Change Notice

FT Series

Changes to Connectors on Touch Screen Controller Board

Changes for FT Controller Board
FTCS05B Shown

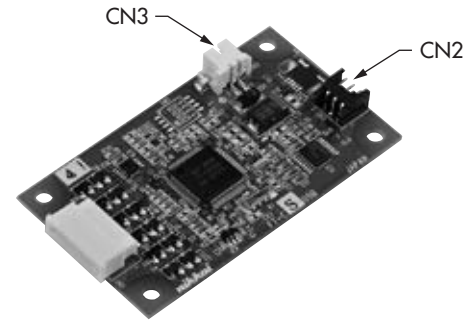
There will be revisions to the connectors for the FT Series Touch Screen controller board for RS232C. The changes will be for the header connectors for CN2 and CN3, and will effect standard part numbers (listed below) and custom part numbers.

| Changes for Touch Screen Controller Board | | | |
|---|--|--|---------|
| FTCS04A FTCS04A2 | CN2: Hirose DF3Z-3P-2H(20) CN3: Hirose DF3Z-2P-2H(20) | CN2: Hirose DF3E-3P-2H(20) CN3: Hirose DF3E-2P-2H(20) | |
| FTCS04B FTCS05B | CN3: Hirose DF3Z-2P-2H(20) | CN3: Hirose DF3E-2P-2H(20) | |

- There are no changes to the receptacle connector or socket that connects to the header connector.
- Contact the factory if further details are needed.
